Westinghouse  
Electric Corporation

NTD-NRC-94-4254  
DCP/NRC0178  
Docket No.: STN-52-003

SUBJECT: WESTINGHOUSE RESPONSES TO NRC REQUESTS FOR ADDITIONAL  
INFORMATION ON THE AP600

NTD-NRC-94-4254  
ATTACHMENT A  
AP600 RAI RESPONSES  
SUBMITTED AUGUST 3, 1994

410.135-1

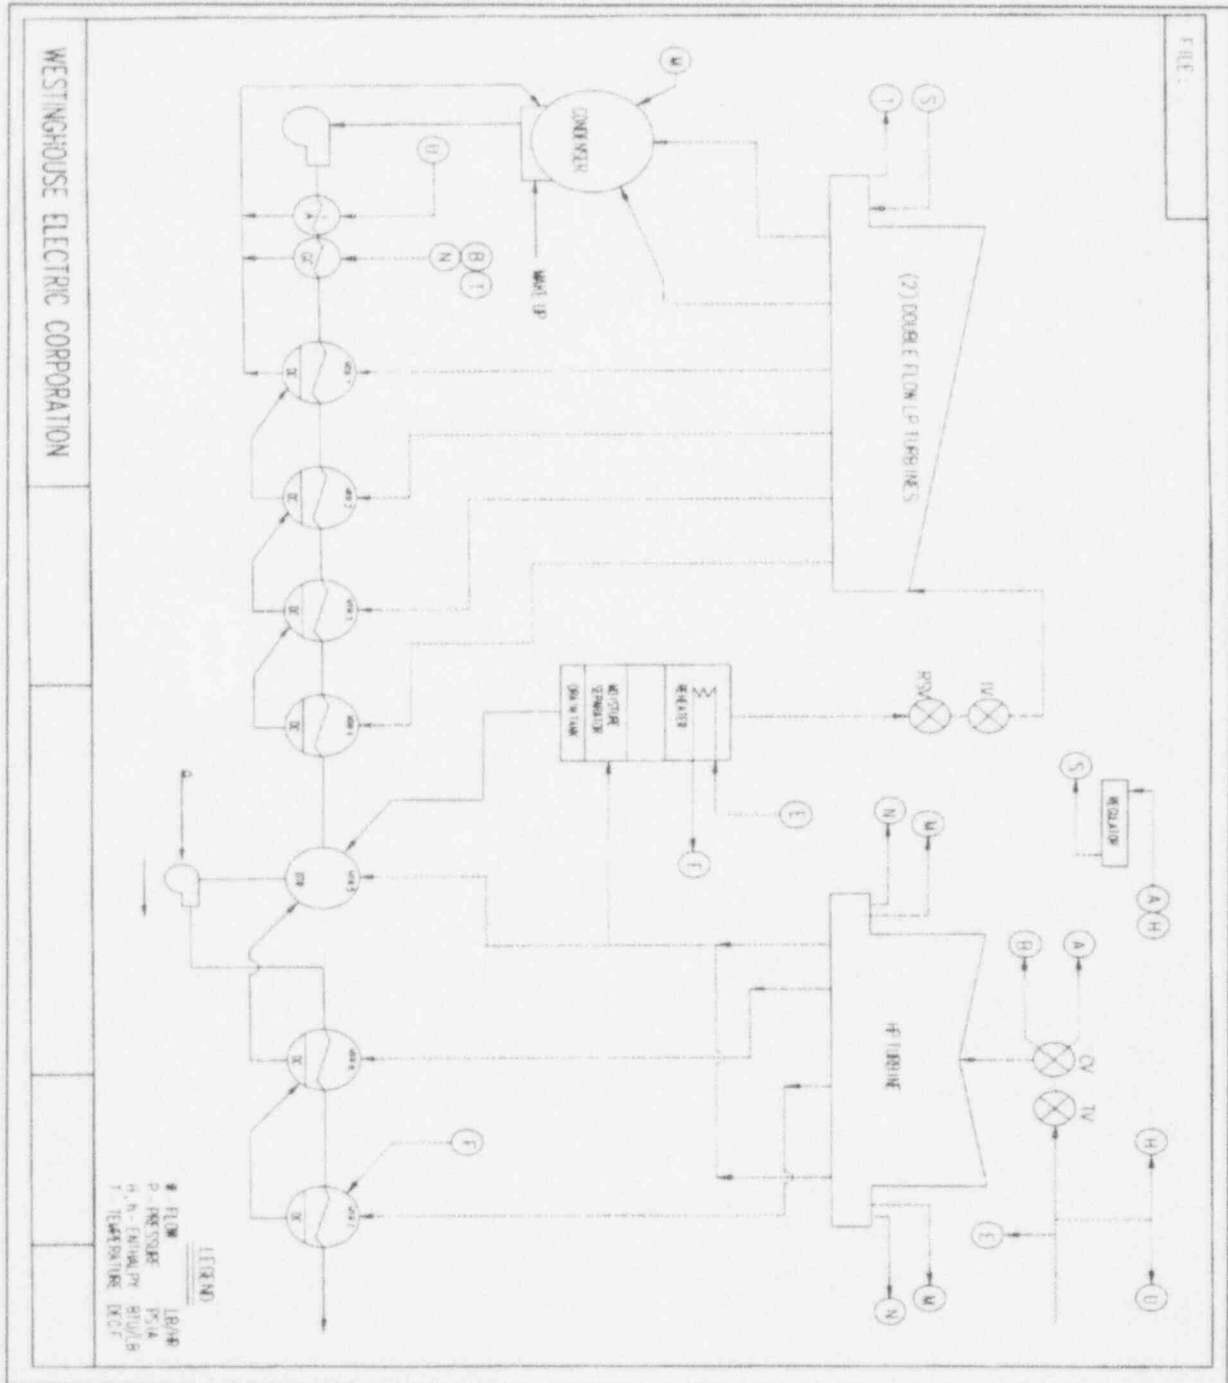
Provide a diagram of the steam and power conversion system in the non-proprietary portion of the SSAR, including a heat balance, in accordance with the guidance in RG 1.70.

A heat balance showing system configuration will be provided as Figure 10.1-2.

Figure 10.1-2 will be added to the SSAR

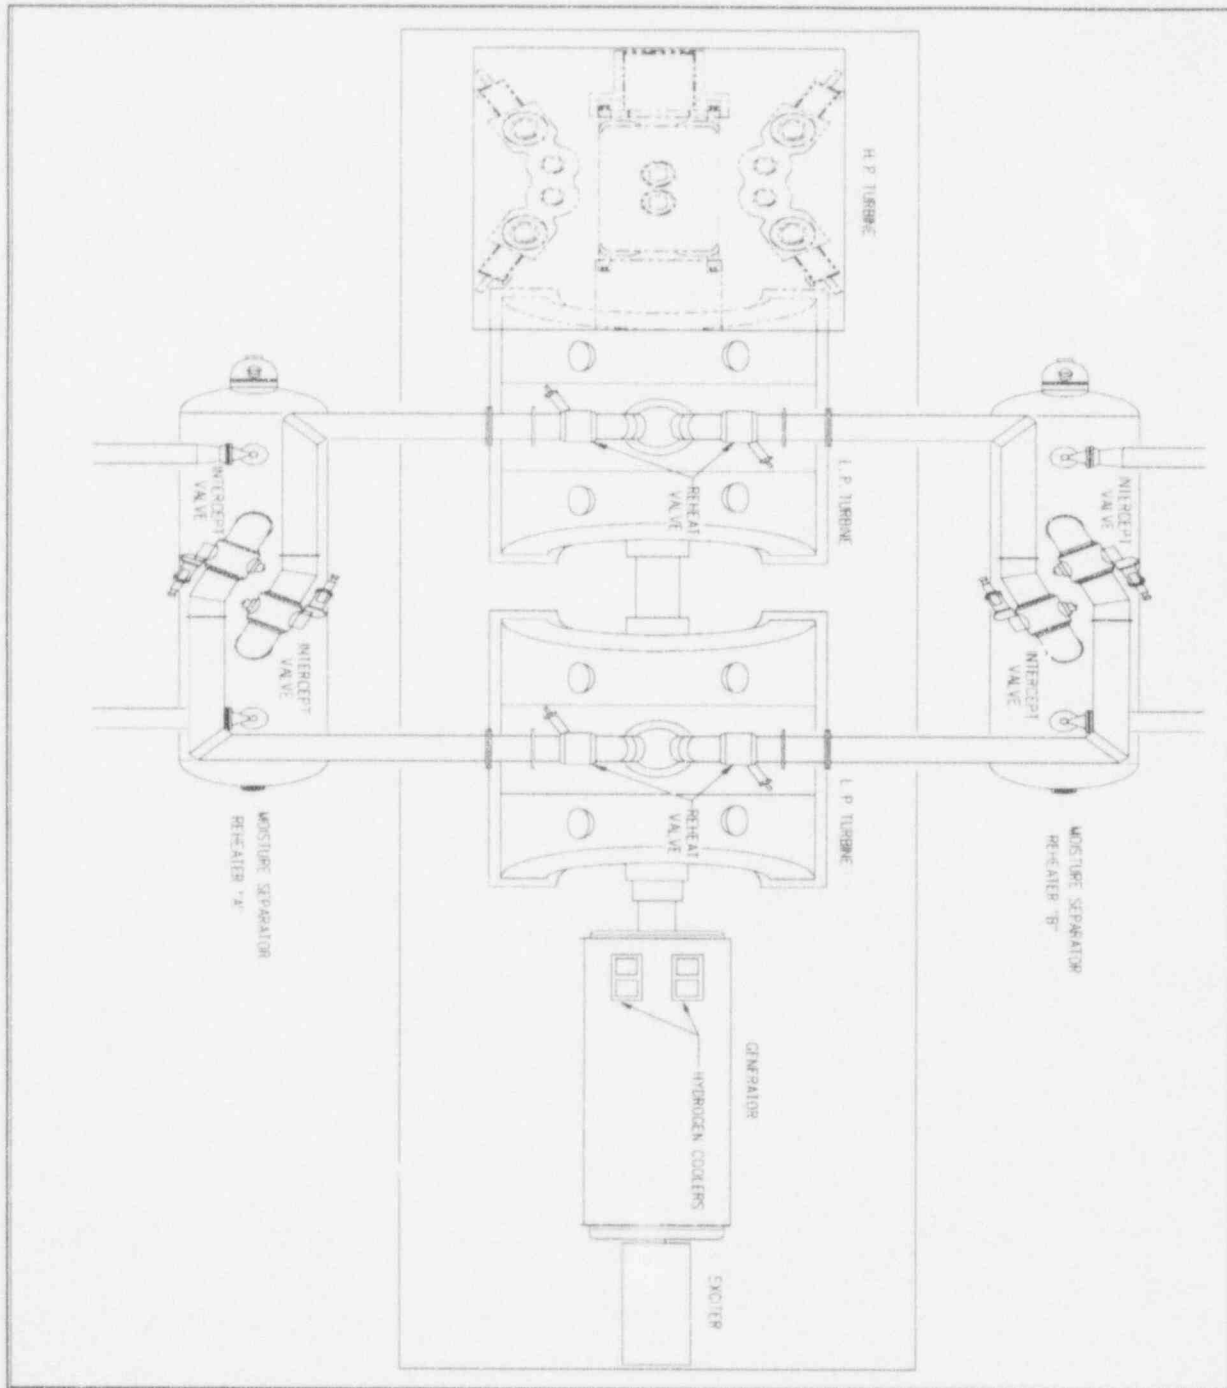
Section 10.2.2 of the SSAR states that the turbine-generator consists of turbines, a generator, external moisture separator reheaters, an exciter, controls, and auxiliary subsystems as shown in Figure 10.2-1. The described components should be in a non-proprietary figure. The function of the exciter is not discussed anywhere in the SSAR. Describe the functions of the exciter in the SSAR.

The components will be indicated on Figure 10.2-2 (Turbine Building Elevation 165 General Arrangement) in the non-proprietary section of the SSAR.

A non-proprietary drawing of the T/G, MSR, Exciter, Controls, and auxiliary subsystems is added to the SSAR as Figure 10.2-2.

SSAR Revision: Revise Subsections 10.2.2 and 10.2.2.3 as follows:
